### **ADDENDUM NO. 1**

Date: 7/11/2017

**Project: Field Improvements at West Campus High School**

**West Campus High School**  
Synthetic Practice Field & Road Improvements, Inc. 1

**C1.8.3**

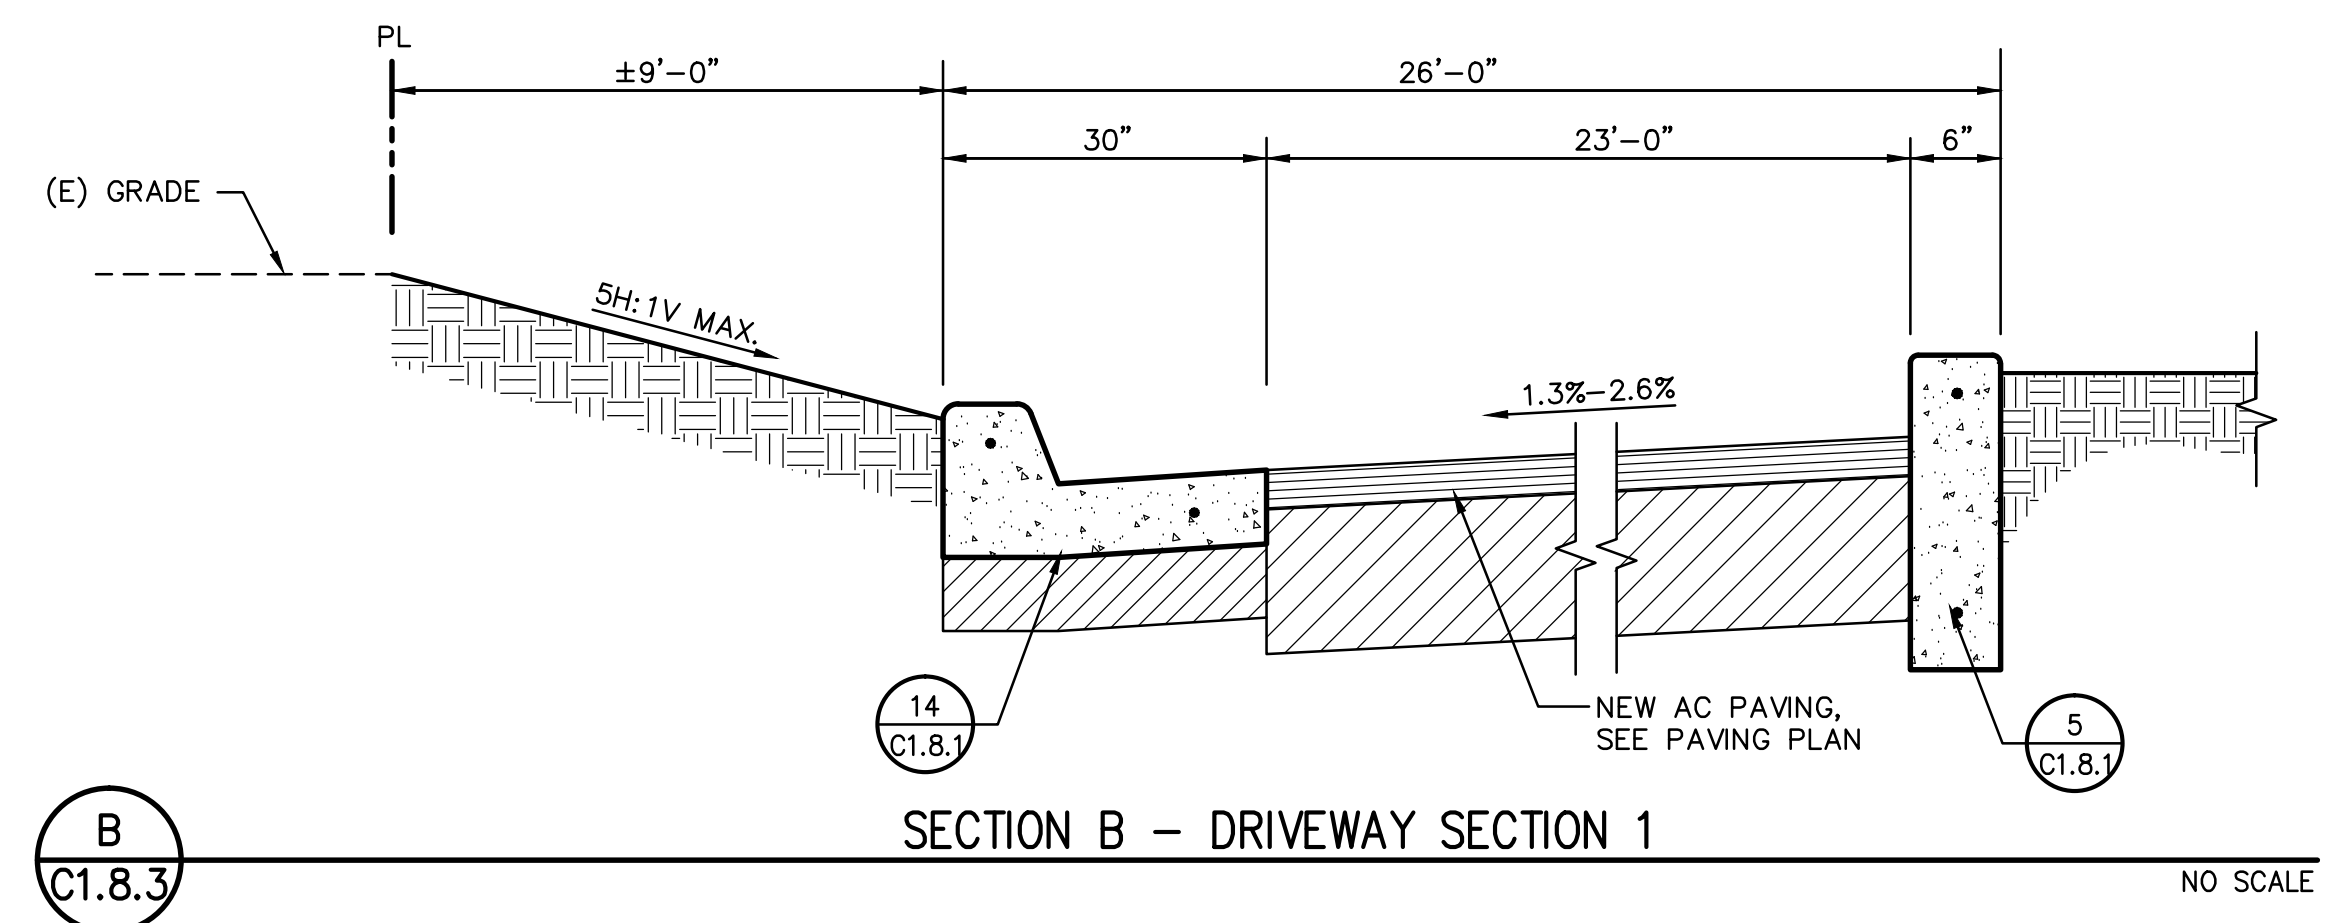
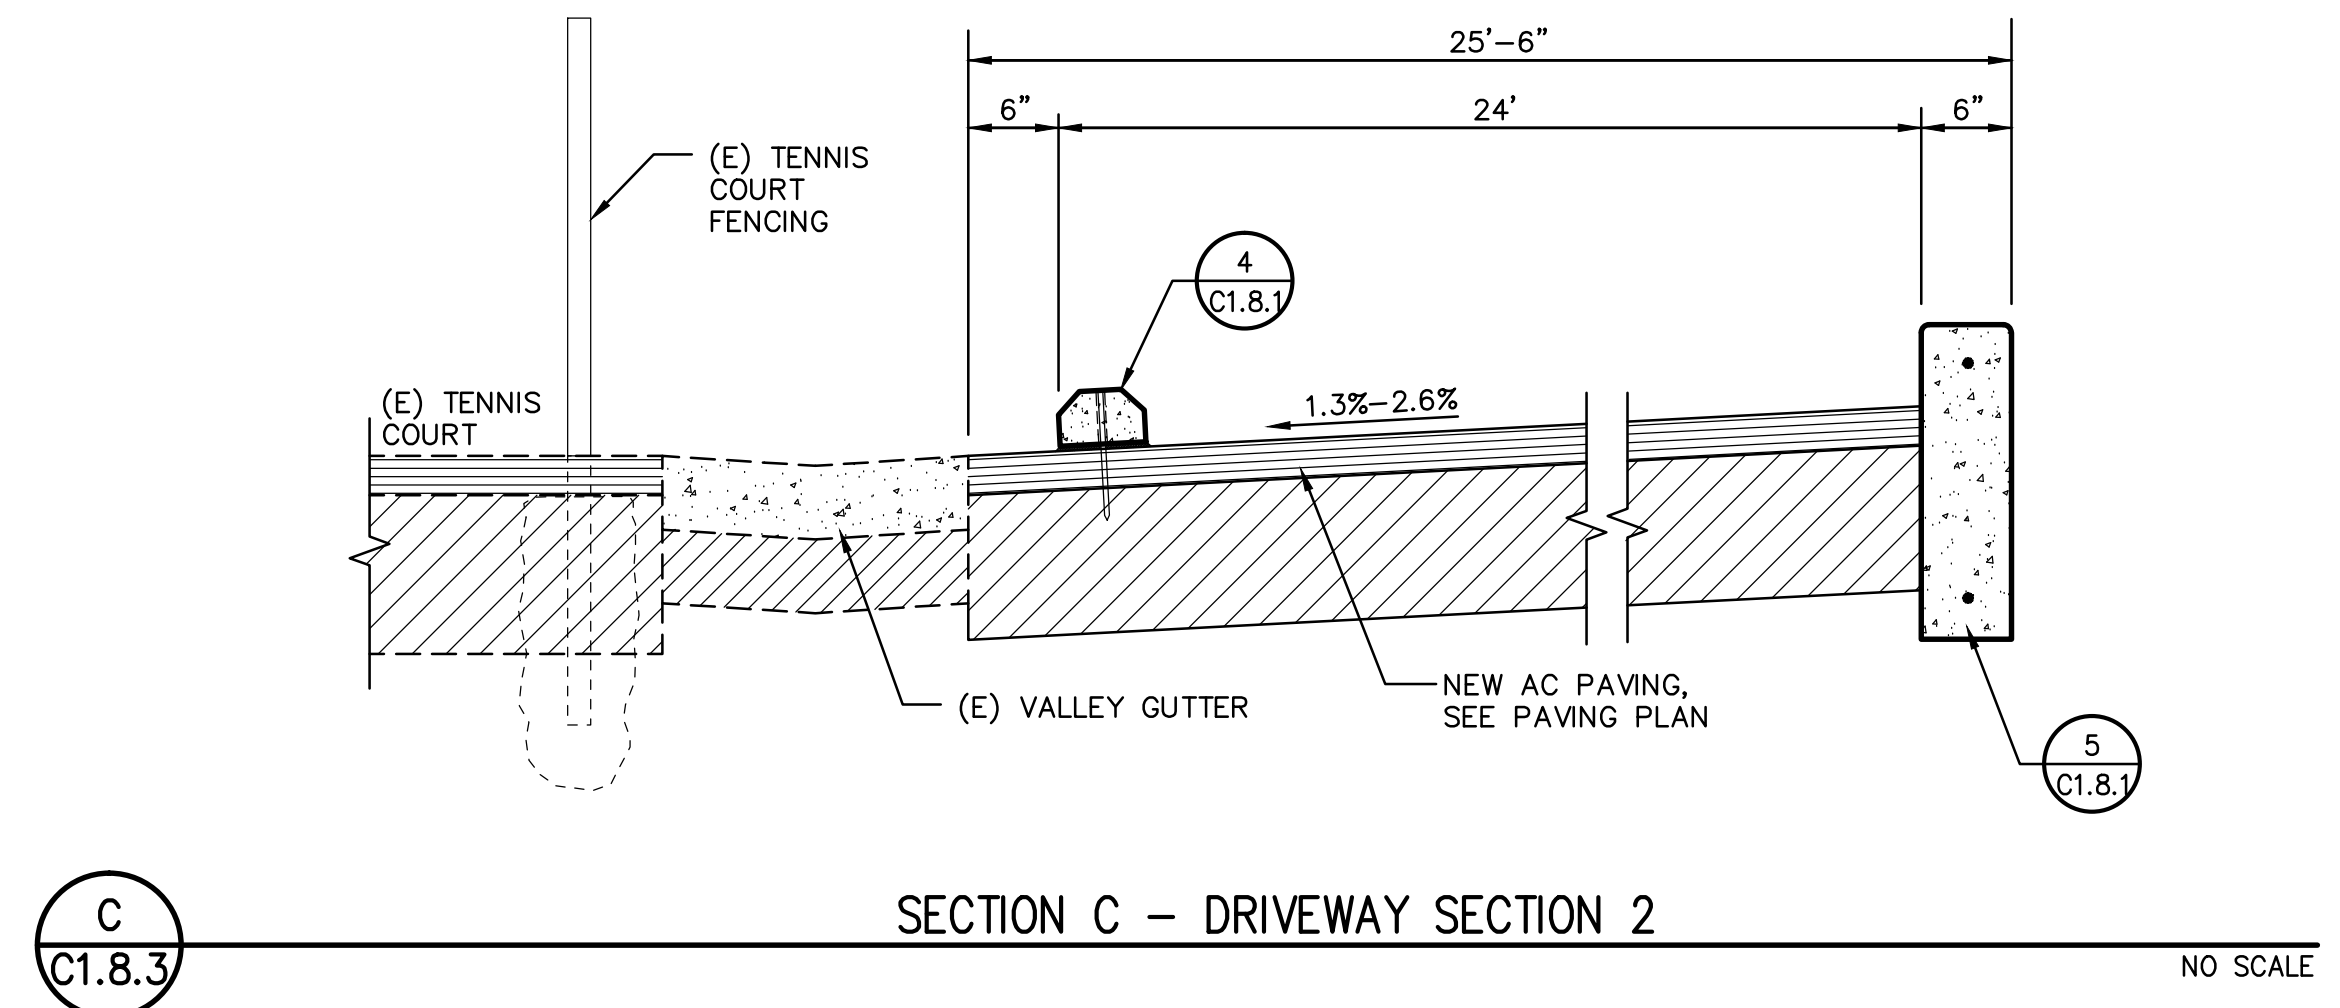
7. AD1-7 FIELD LAYOUT PLAN
  - a. Ground sleeves and soccer lock down to be installed at both goal ends.
8. AD1-8 FIELD FENCING AND EQUIPMENT PLAN
  - b. Only goal sleeves to be installed, goal posts to be provided but not installed.
9. AD1-9 FIELD FENCING SECTIONS AND DETAILS
  - c. Goal post to be provided but not installed.
10. C1.6.5 FIELD EQUIPMENT DETAILS
  - d. Some equipment not used.
11. C1.8.3 DETAILS AND SECTIONS
  - e. Field section detail updated.
